Access Compliance Report

Public Rights-of-Way

(Curb Ramps)

Intersection ID: 51353	Main Street: MCCULLOUGH_DR	Cross Street: BRENTMOOR_DR	Location: SW
ADA ID: F4BB35A81E23	Ramp Type: PerpDiag	Initial Pass/Fail: Fail	Overall Compliance: No
Severity Score: 22.5			
Codes/Mitigation Info/Possible Solution		Field Measurements/Component Compliance

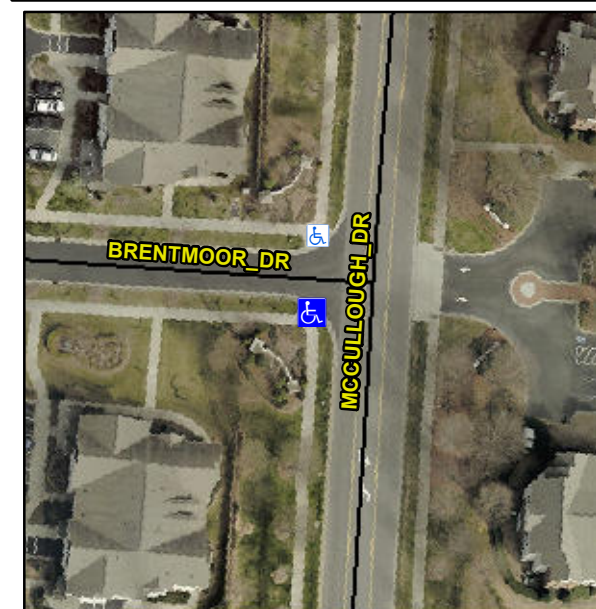
Not Found, R304.5.1, R304.2.2, R304.5.3

Compliance	Description	Data	Compliance	Description	Data
N/A	Ramp Length (in)	59.0	No	Ramp Slope (%)	9.6
No	Ramp Width (in)	47.0	No	Ramp XSlope (%)	2.7
N/A	Flare Type LT	N/A	N/A	Flare Type RT	N/A
N/A	Flare Slope LT (%)	N/A	N/A	Flare Slope RT (%)	N/A
N/A	Flare Traversable LT?	N/A	N/A	Flare Traversable RT?	N/A
N/A	Landing Length (in)	N/A	N/A	DWS Provided?	N/A
N/A	Landing Width (in)	N/A	N/A	DWS Contrast?	N/A
N/A	Landing Slope (%)	N/A	N/A	DWS Length (in)	N/A
N/A	Landing X Slope (%)	N/A	N/A	DWS Full Width?	N/A
N/A	Landing Curb? (Y/N)	N/A	N/A	DWS Offset (in)	N/A
N/A	Shared Landing?	N/A			
N/A	Gutter Ponding?	N/A	N/A	Gutter Slope (%)	N/A
N/A	Gutter Lip Ht (in)	N/A	N/A	Gutter X Slope (%)	N/A
N/A	Painted X Walk1?	No	N/A	Painted X Walk2?	No
	X Walk 1 Direction	To E		X Walk 2 Direction	To N
N/A	X Walk 1 Width (in)	N/A	N/A	X Walk 2 Width (in)	N/A
	X Walk 1 Slope (%)	5.8		X Walk 2 Slope (%)	0.4
	X Walk 1 X Slope (%)	0.7		X Walk 2 X Slope (%)	3.8

Remove & Replace Curb Ramp With Two New Directional Ramps or Equivalent.
